SERVICE BULLETIN

No. ³¹⁵

Subject: V_{ne} Airspeed Limit

Models Affected: PA-30 Twin Comanche

SK-2202

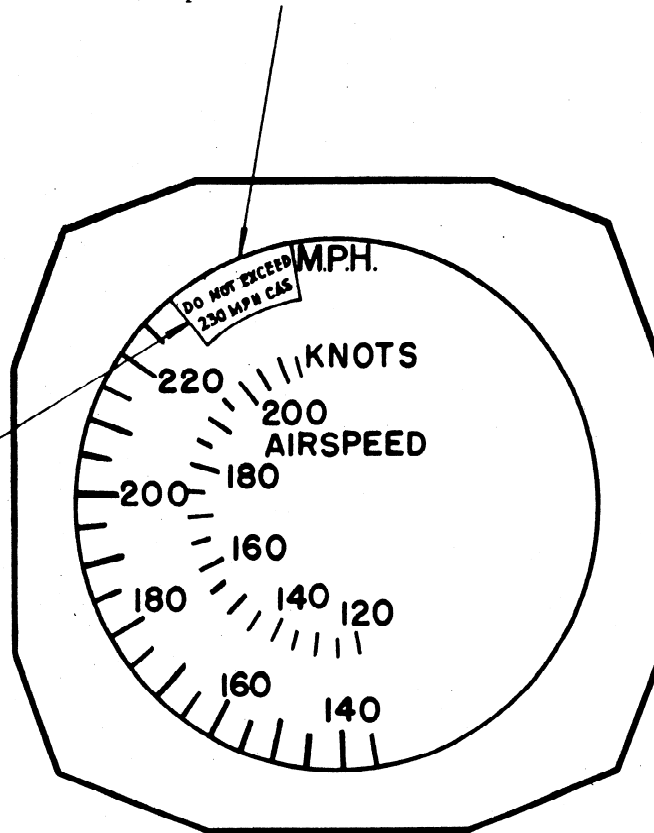
Purpose: To revise the existing V_{ne} Airspeed Limit of 245 mph C.A.S. to a V_{ne} Airspeed Limit of 230 mph C.A.S.; reference FAA Airworthiness Directive dated July 2, 1970.

Instructions: Install airspeed indicator placard part number SK-2202 on the face of the airspeed indicator, as denoted by the sketch on the reverse side of this bulletin.

Install Placard SK-2202 on the face of the Airspeed Indicator as shown.

Locate this edge of Placard SK-2202 at 230 M.P.H.
